SUBJECT: COMANCHE PEAK NUCLEAR POWER PLANT, UNIT 2 - SUMMARY OF
CONFERENCE CALL REGARDING THE SPRING 2011 STEAM GENERATOR
TUBE INSPECTIONS (TAC NO. ME5826)

SUMMARY OF APRIL 14, 2011, CONFERENCE CALL
WITH LUMINANT GENERATION COMPANY LLC
REGARDING THE SPRING 2011 STEAM GENERATOR
TUBE INSPECTION RESULTS
AT COMANCHE PEAK NUCLEAR POWER PLANT, UNIT 2
DOCKET NO. 50-446

NRC – Luminant Phone Call on Comanche Peak 2RF12 SG Inspection
April 14, 2011

Figure 1. General Location and Designation of Tube Support/Baffle Plates (designations in parentheses show eddy current test terminology)

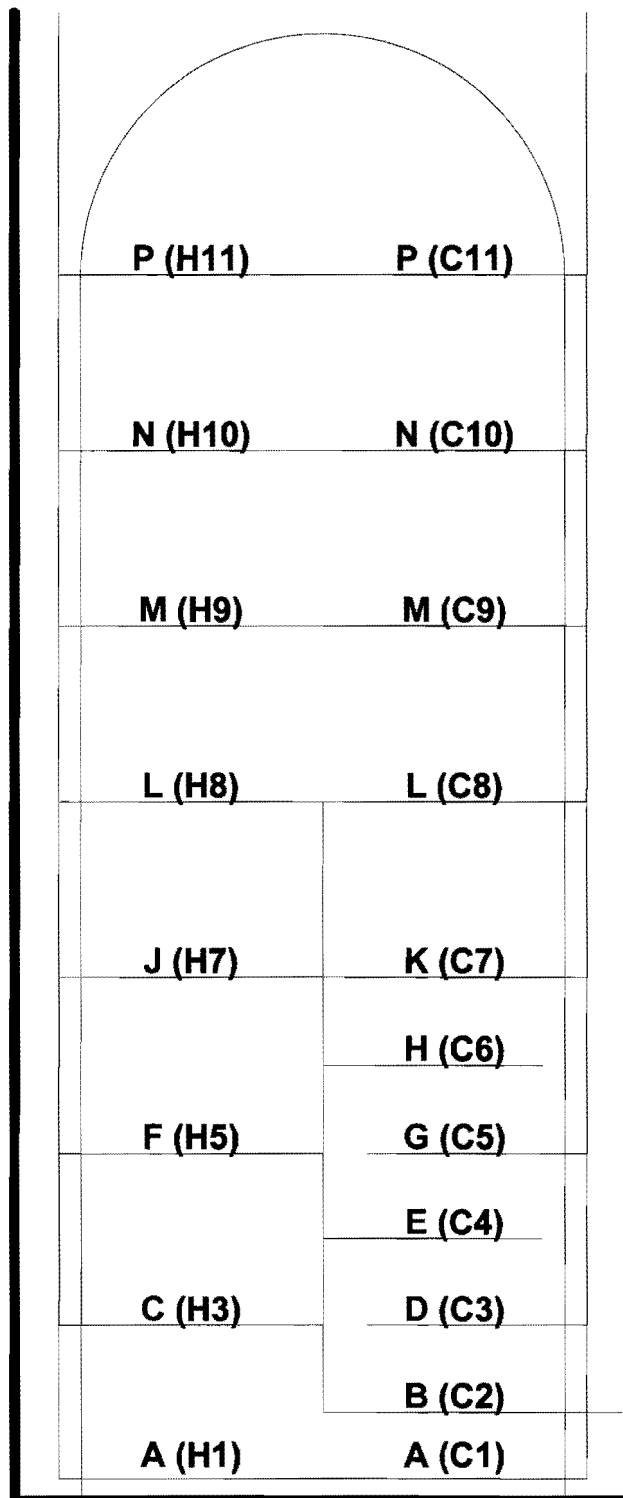
8. Please discuss the following regarding loose parts:

- what inspections are performed to detect loose parts;

During normal operation feedwater is discharged into a “water box” in the SG from which it flows into the preheater above the baffle plate B (see Figure 1) in the cold leg. As a result, loose parts enter the SG over baffle plate B. Therefore close attention is paid to this region. Video inspection is performed over baffle plate B in all SGs. In particular, the periphery and the T-slot are inspected. These are the areas of highest potential for loose parts accumulation and tube damage. If video inspection detects the presence of a loose part (either over the tubesheet or over baffle plate B), the adjacent tubes are inspected by +Point to detect and quantify any tube degradation.
